Approved Development:	Demolition of existing structures and construction of a residential apartment building containing 38 apartments and 3 basement parking levels
Proposed Modification:	S4.56 modification to DA18/0323 - amendments to the driveway, basement garage and filtration tank, fence height increase and reinstatement of green wall
Property:	S/P 545, S/P 9336, S/P 48254, 5 Ozone Street, Cronulla
Applicant:	The Trustee For Ozone Cronulla Unit Trust
Owner	Strata Plan 48254 Proprietors
File Number:	DA18/0323
Application Number:	MA24/0086 PAN-428218
To be determined by:	Senior Manager/Council staff under delegated authority
Report from:	Senior Development Planner (Daniel Lukic)

2.0 DESCRIPTION OF PROPOSED MODIFICATION

Image 5: The modified basement access ramp

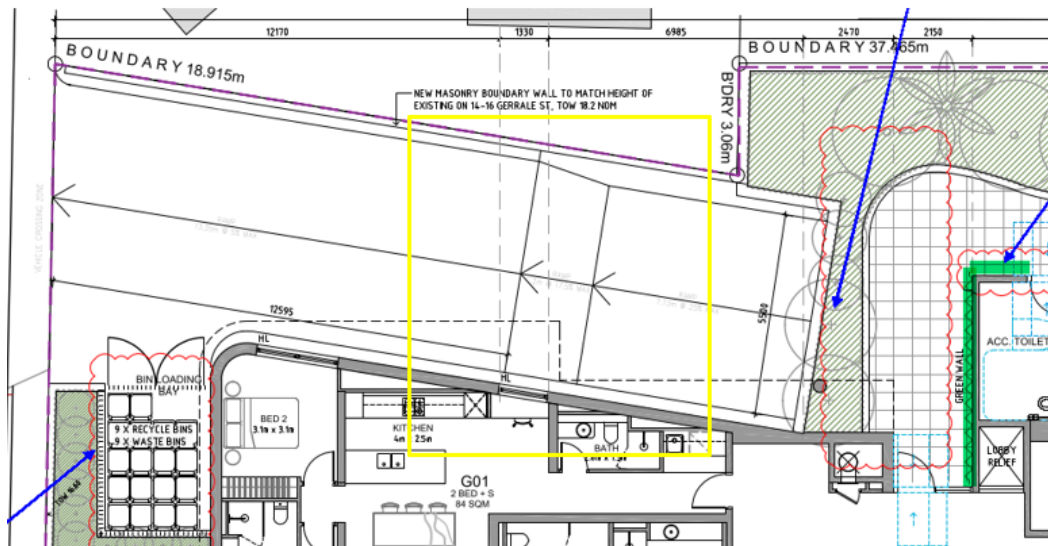
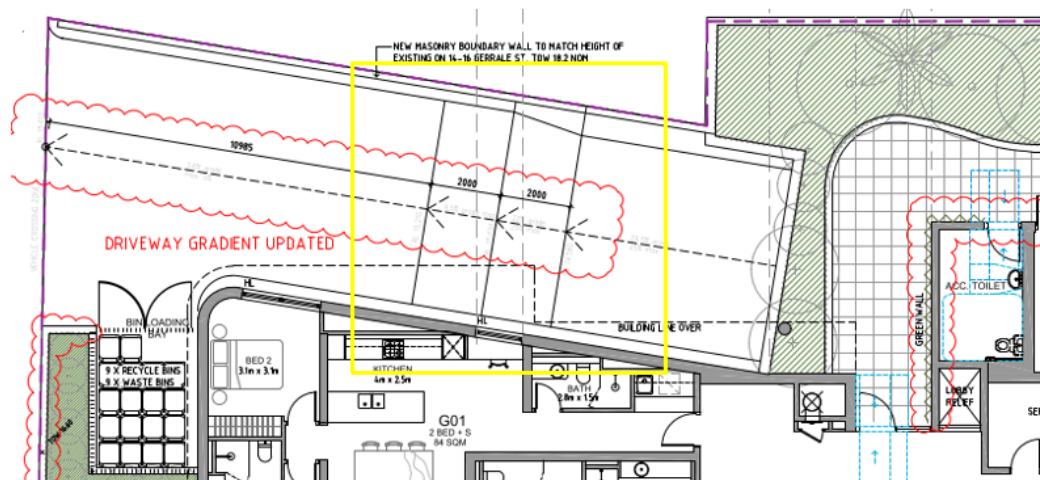
The applicant has advised that the ramp has been constructed and following inspection, it was established that the connection between the ramp and basement entrance is too steep and short for a B85 passenger motor vehicle. The applicant engaged a traffic engineer who reviewed the ramp and advised that the works are required to ensure the ramp gradient and transitions satisfy AS2890.1 and Chapter 36 from SSDCP2015.

The first image below shows a single transition between the ramp from the verge and the basement entry, and the ramp gradient had a maximum 5% grade for 13m. The second image shows two transitions, each being 2m long, to address the shortcomings of the constructed access. The proposal will alter the ramp grades to 3.6% for 10.98m and then 9.7% for the following 2m.

Following detailed assessment, no issues have been raised by the Assessment Team's Engineer and the changes are supported.

Image 7: Plan extract of the proposed basement level 3 layout

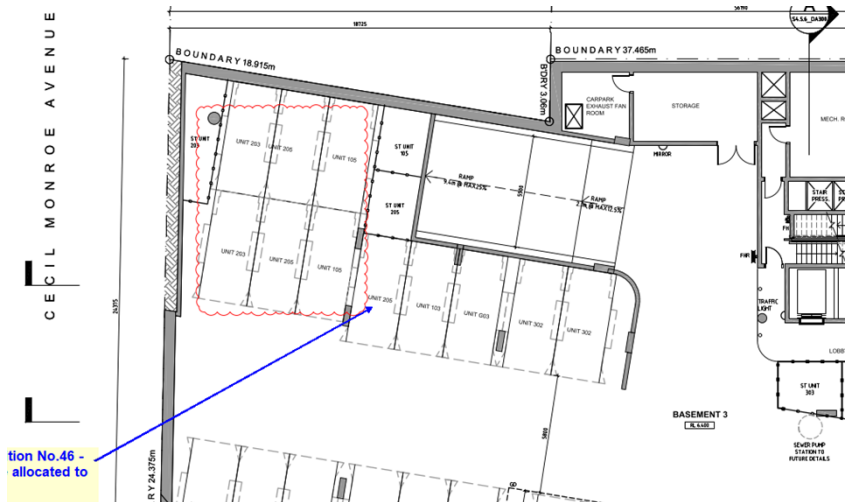
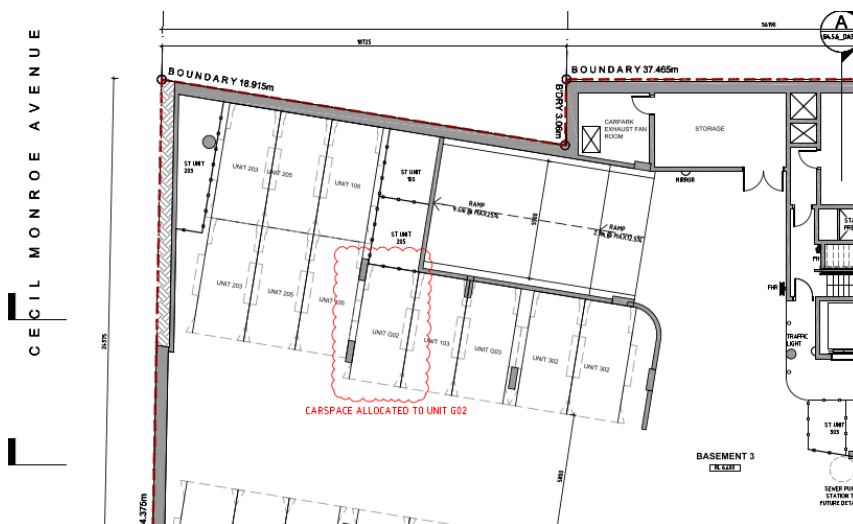
The approved Basement Level 3 shows Apartment 205 has 3 parking spaces allocated and Apartment G02 did not have any parking entitlement. This MA seeks to reallocate one of the three parking spaces allocated to Apartment 205 to ensure that each apartment has one parking entitlement.

The reallocation of one parking space from Apartment 205 to G02 does not create any shortfall or non compliance to the parking control contained in SSDCP2015. Therefore, the proposal is supported.

Image 9: Plan extract of the proposed basement level 3 layout

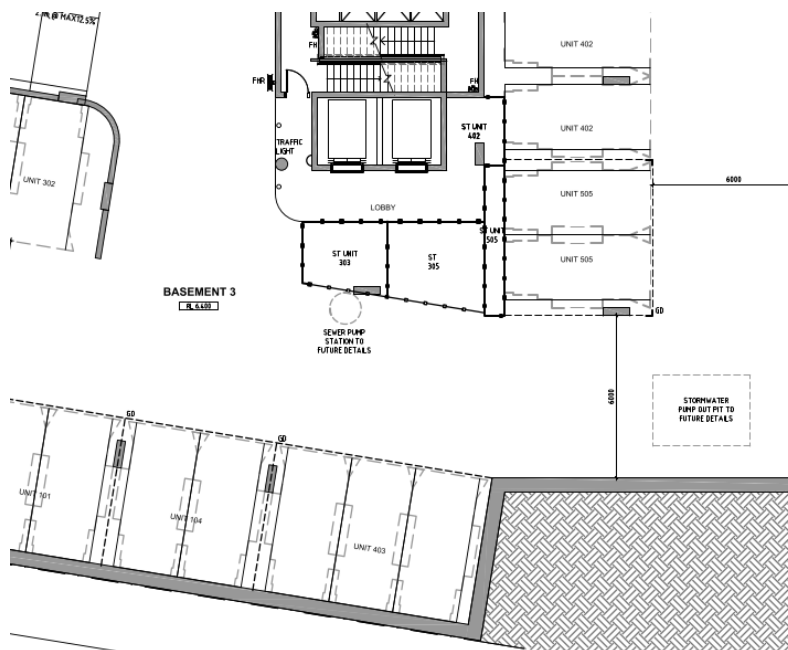
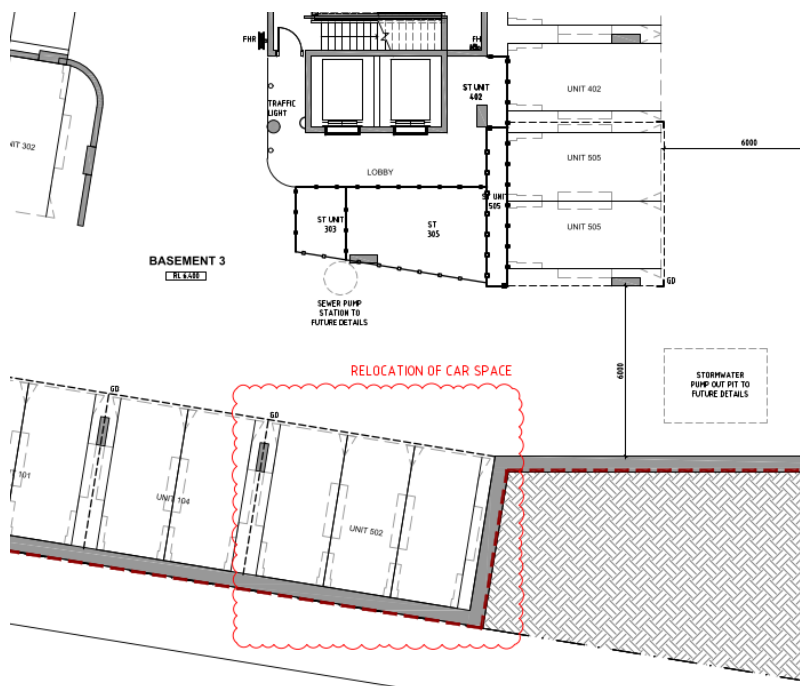
- Car parking spaces for Unit 403 are reallocated to Unit 502.

The approved Basement Level 3 plan shows Apartment 403 has 3 parking spaces, and Basement Level 1 plan shows Apartment 502 has 3 parking spaces. Essentially, the proposal is to swap the parking

entitlements between the levels. As there is no loss in parking spaces and apportionment remains the same, the change is supported.

Image 15: Proposed civil plan showing the OSD, the new Jellyfish tank and drainage pipe detail.

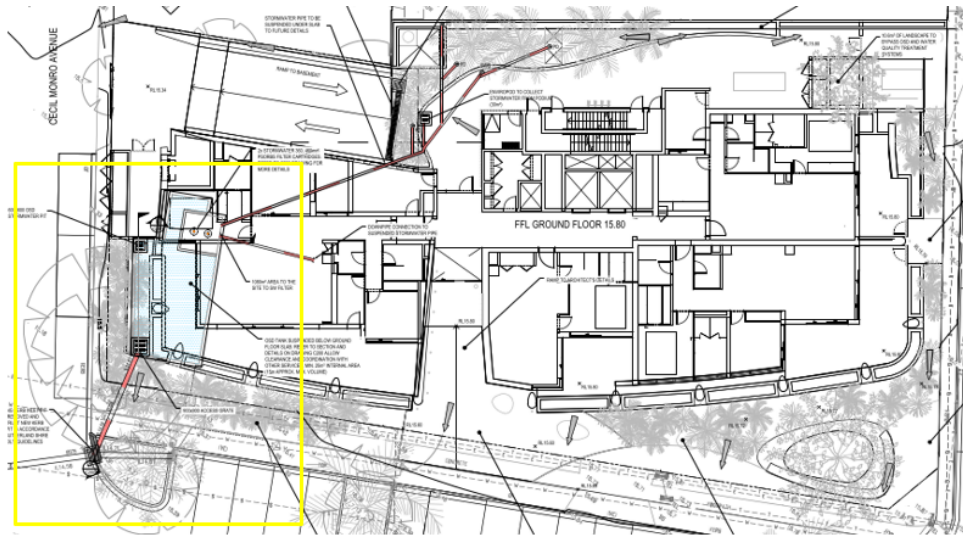
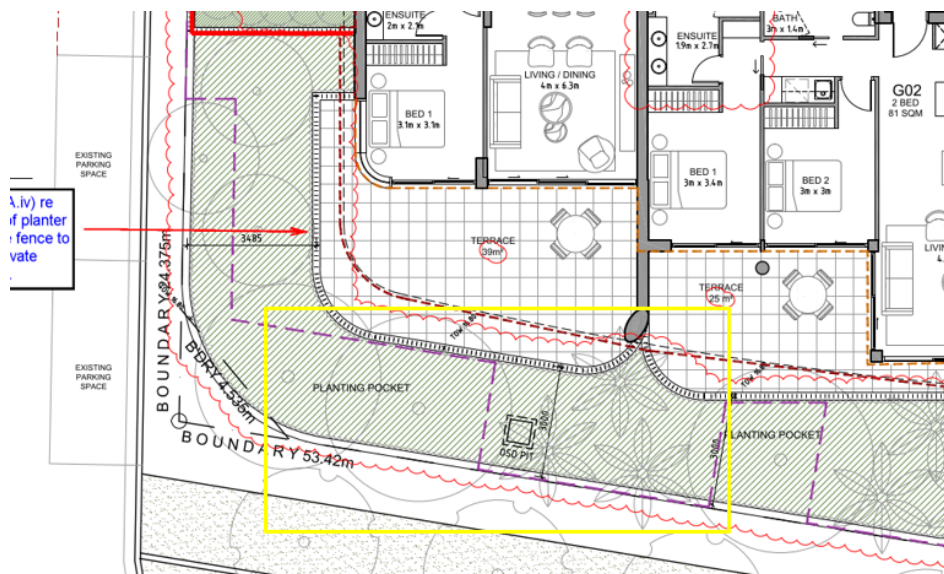
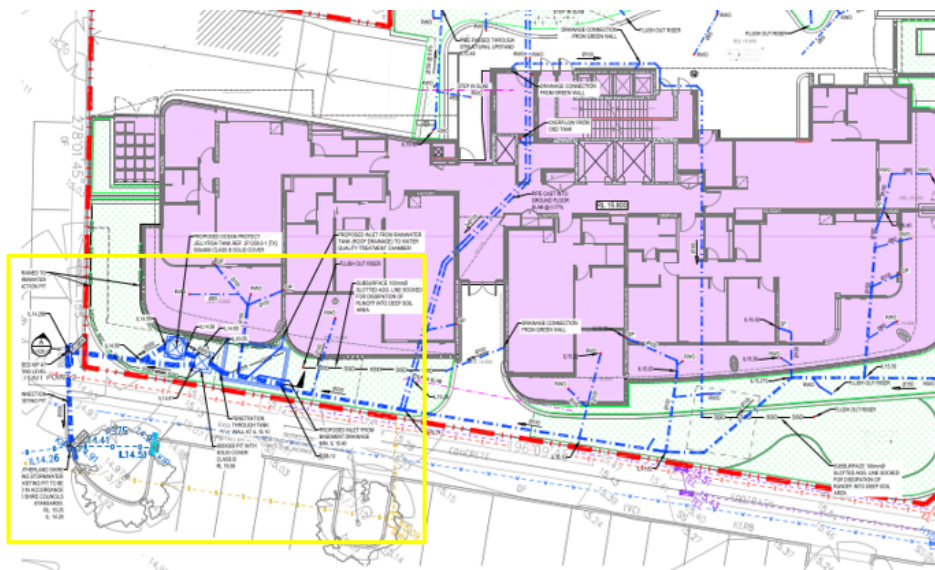
The original application approved the drainage vessel/onsite detention (OSD) tank in the southwest corner of the site with a pipe connection to the kerb. The OSD tank was partly located adjacent to Apartment G01 and its private open space area and extends into the landscape strip adjacent to Cecil Munro Avenue.

The location was altered in Modification Application MA21/0080 where the onsite detention basin was moved northward from the corner and located in front of the private open space area of Apartment G01. There were no civil plans or any details in the application proposing to relocate the OSD system, but some notations were made on the architectural plans. The Construction Certificate drawings from CC21/0486 showed the approved location aligning with MA21/0080.

The current modification application seeks to retain the OSD tank in the location referred above, but the application seeks approval for:

- A revised pipe alignment and connection to the kerb.
- The installation of a new water treatment ('Jellyfish') tank to the south of the OSD tank.
- Internal changes to pipe location and sizes as a result of the new water treatment tank.

Initially Council's Engineers raised some concerns with the proposal and a request for more information was sought. Following a review of revised information and details, no objections are raised.

From a landscaping perspective, the tanks will be located below the raised planter beds located adjacent to Cecil Munro Avenue and Ozone Street. The soil depth above the infrastructure will be 1m which will allow for medium sized trees to be planted, resulting in minimal visual impacts and/or impact the ability for landscaping to grow and reach maturity.

Image 17: The proposed fence/raised planter treatment along the Ozone Street elevation.

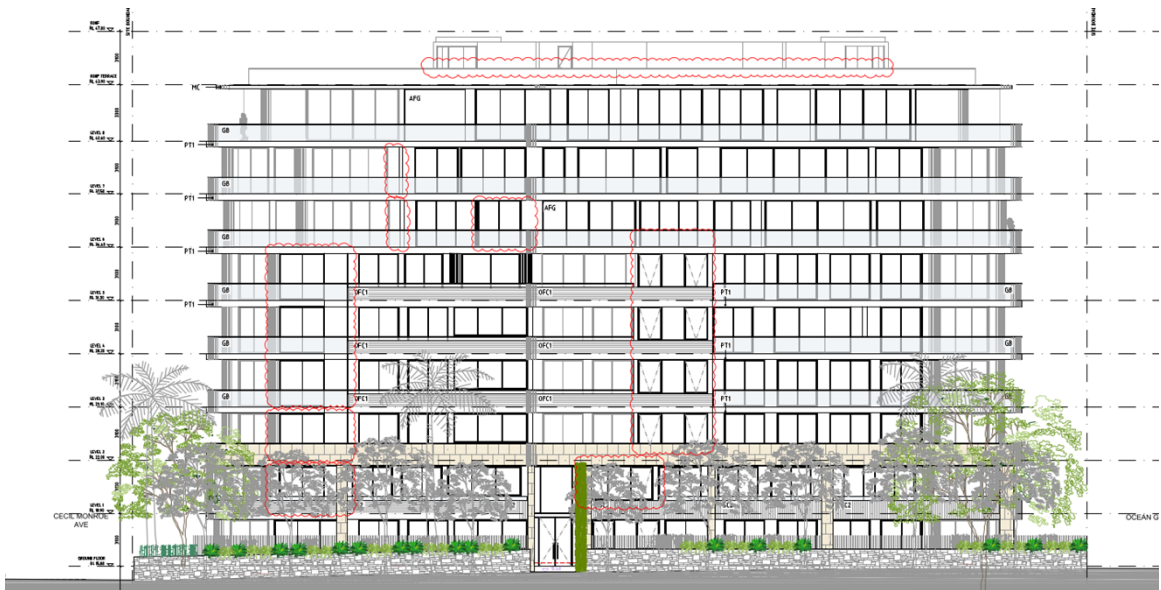
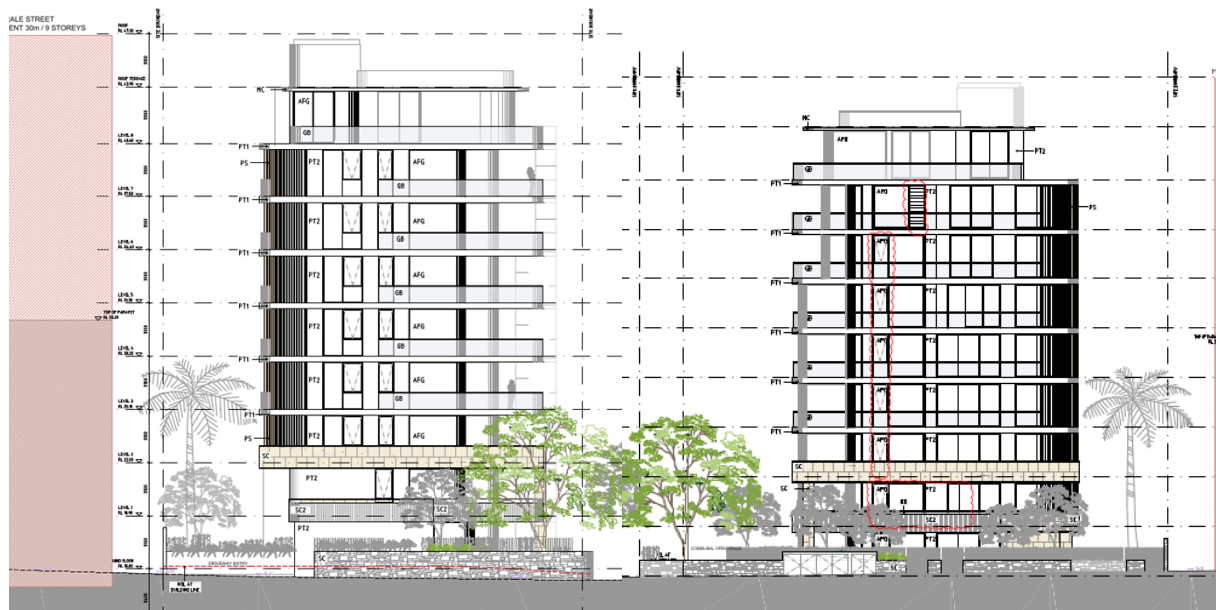
The approved height of the fence/raised planter along the northeastern part of Ozone Street was 1.2m above the existing ground level and this provided sufficient soil depth for the approved landscaping. In November 2022, a modification application was approved, and a condition was imposed limiting the fence/raised planter to no higher than 0.4m. It was determined that the 0.4m raised planter would not provide sufficient soil/growth media and that a depth of 1m is required to ensure the long term health and survival of the landscaping, particularly as this will allow for the planting of canopy trees.

The lifting of the raised planter will ensure the long term health and survival of landscaping for the site and will achieve the landscaping outcomes required by the SSDCP2015. From the public domain and at the human scale, the increased height of the raised planters will not be discernible and will also aid in improving the building aesthetic of the front elevation of the building form.

Image 22: Plan showing the reinstatement of the green wall.

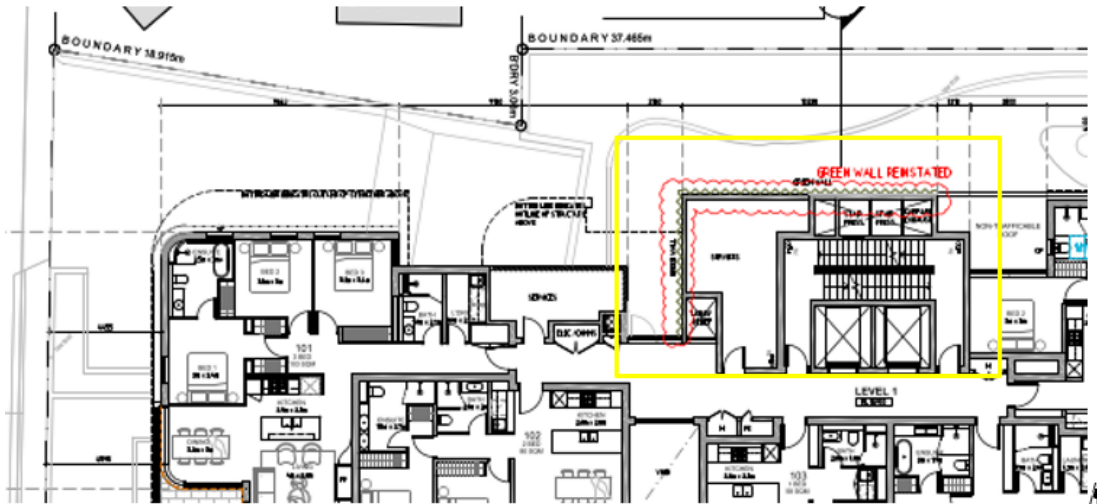
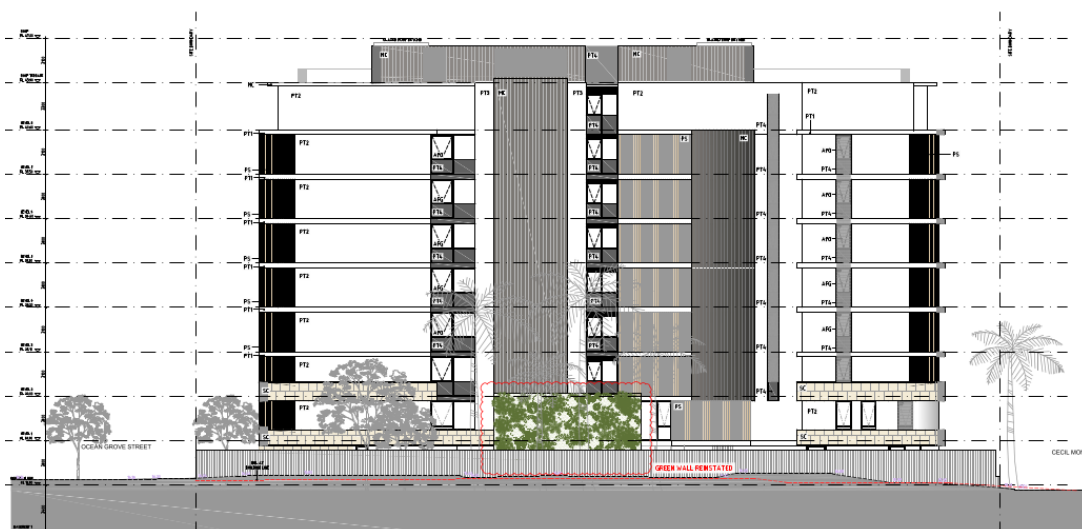
Consent is sought to reinstall the greenwall on the first floor. In a previous modification application, it was deleted, but the applicant has recognised that the landscaping feature will provide the future

No issues are raised, as the reinstatement of this landscaping element will result in improved building aesthetic outcomes.

Image 24: Ground floor plan extract.

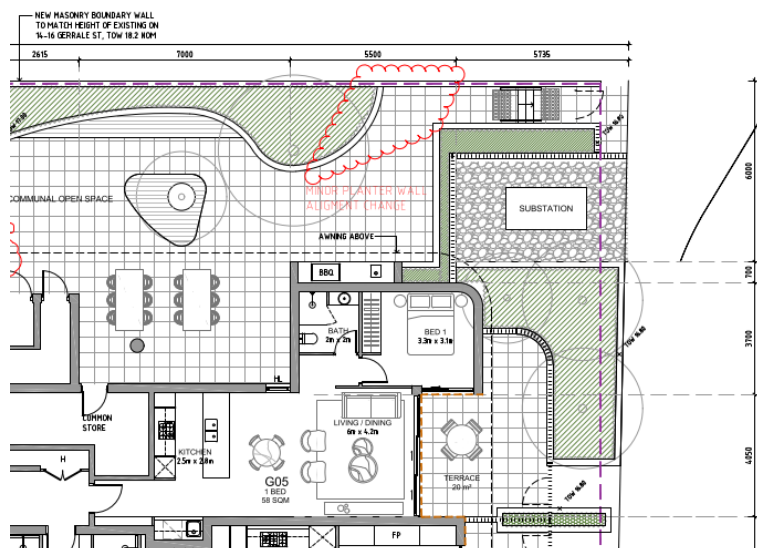
A review of the application has revealed there is a misalignment between the ground floor and the northern elevation plan. The former shows the power kiosk will have an open aperture to the northern property boundary and the latter showing a raised planter across this part of the site. The raised planter is not supported as this will prevent 24 hour access to the infrastructure by the relevant power authority. A condition is imposed for the deletion of the raised planter immediately in front of the kiosk.

- vii) (Deleted – 29 November 2022)
- viii) **To remove the inconsistencies between the ground floor and the northern elevation plan and ensure a positive streetscape outcome, the raised planter shown directly in front of the power kiosk must be replaced with a gate comprising vertical palisade elements that are consistent with the approved perimeter fencing height and materials. The gate will give access to the kiosk and must have a nil street setback. The gate materials must be certified by the PCA and/or a suitably qualified or practicing fire engineer.**

To ensure a positive building and streetscape aesthetic is achieved, a condition is imposed for the installation of a 1.8m high palisade gate across the full width of the kiosk aperture and the colour must be consistent with the raised planter box treatment.
